Subject: Addendum to the Approved Workplan; Fuel Leak Case No. RO0000317; Mash Petroleum, 5725 Thornhill Drive, Oakland, CA

Based on our telephone conversation, this letter is an addendum to the approved Workplan prepared by Aqua Science Engineers Inc. to address some of the concerns I expressed regarding the subject property.

Site map showing locations of proposed hydropunches.

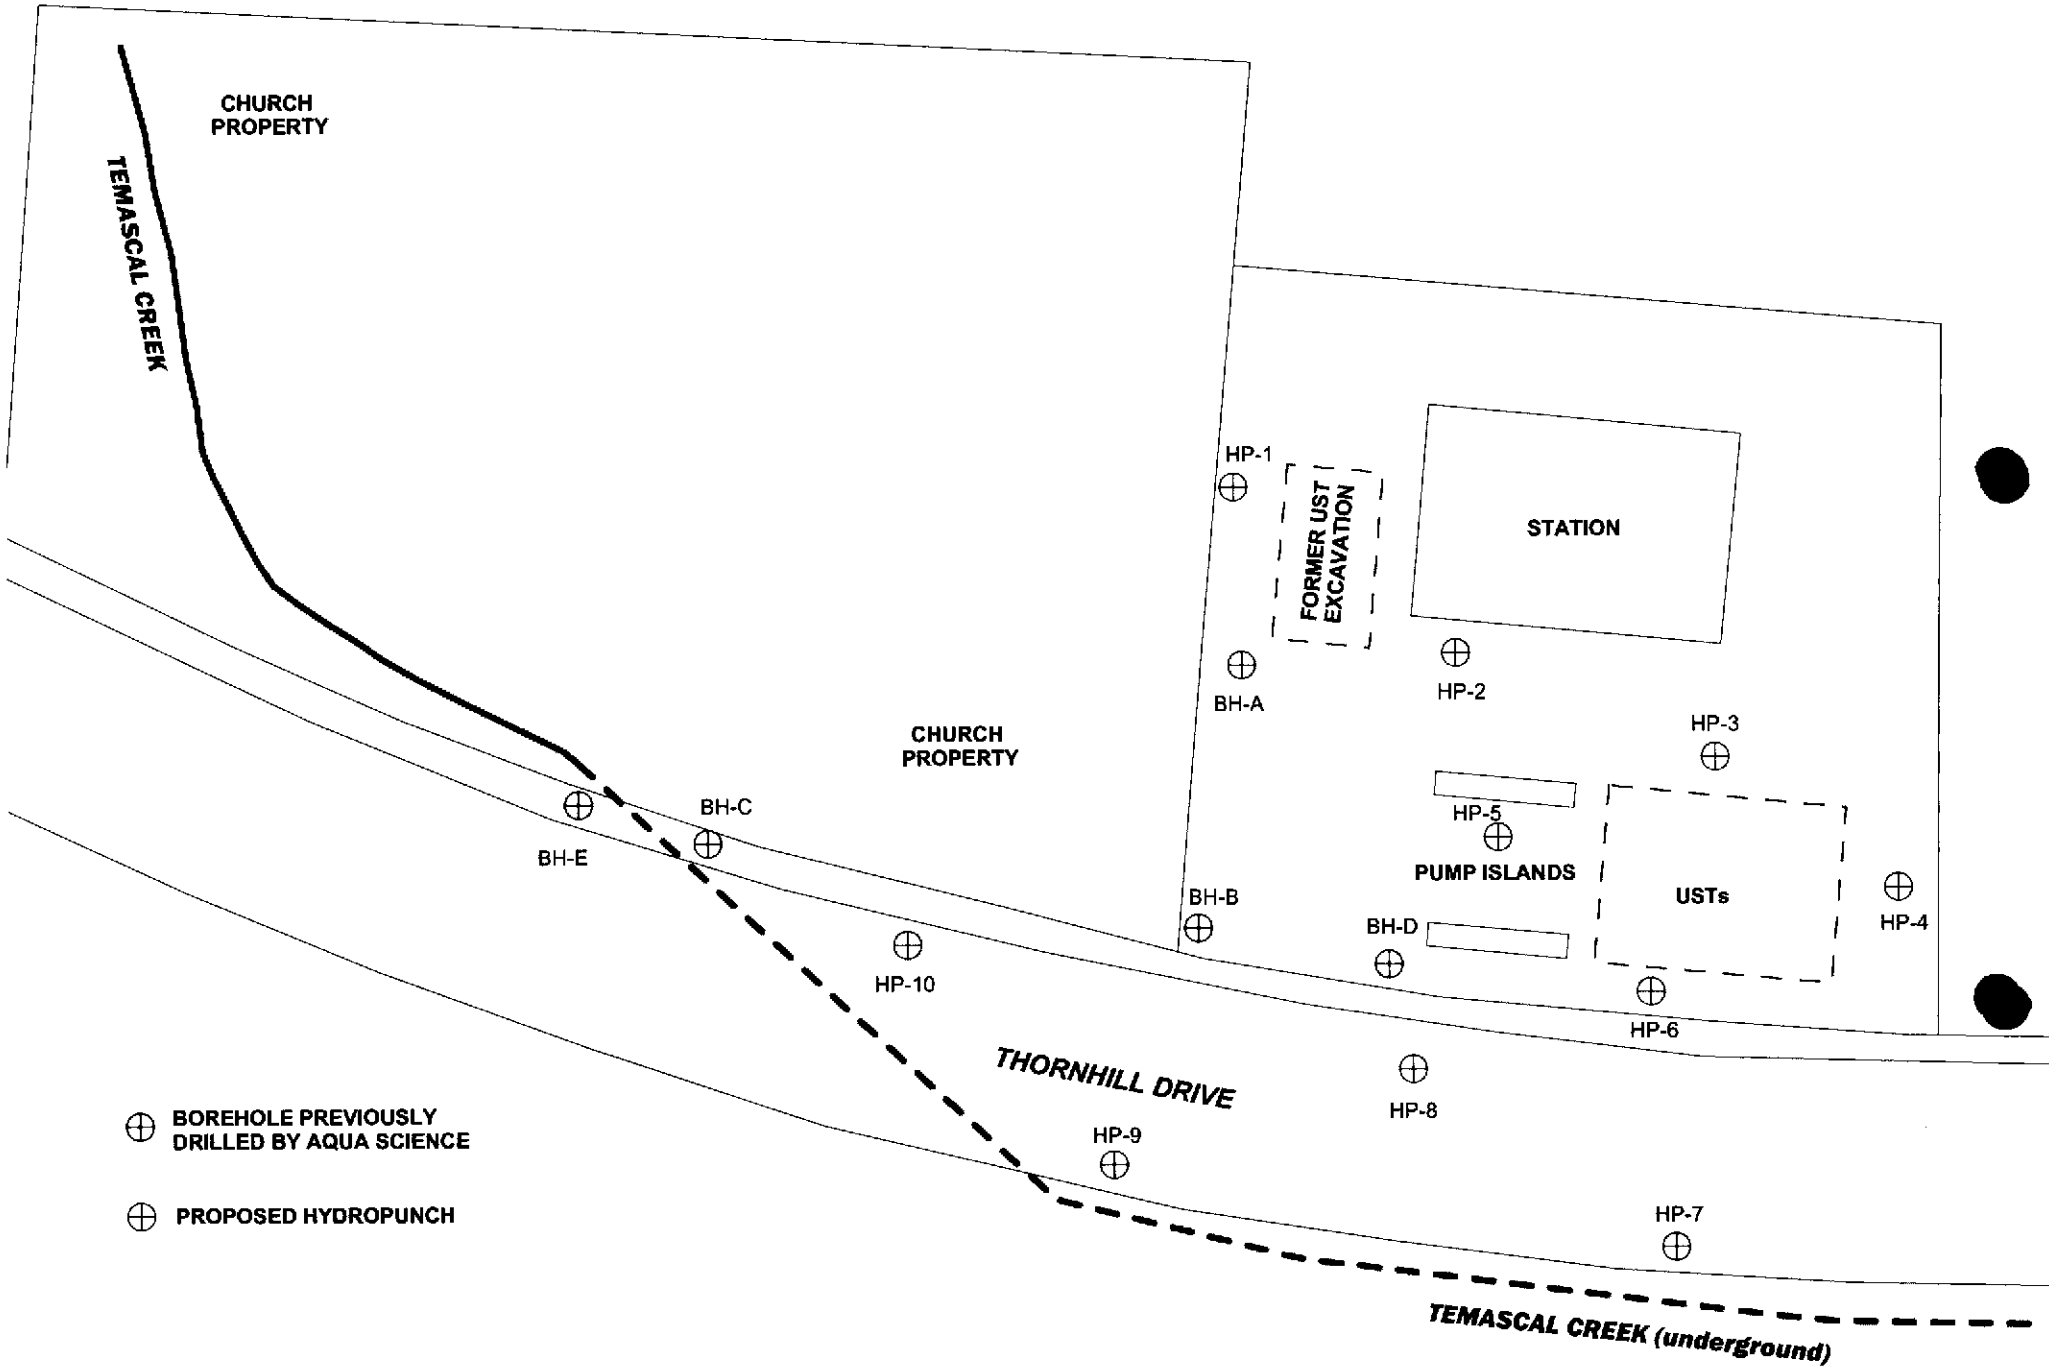
1. Drill 10 hydropunches using direct push technology (DPT), perform continuous logging and collect soil and groundwater samples. The locations of the proposed hydropunches are presented in the attached figure;
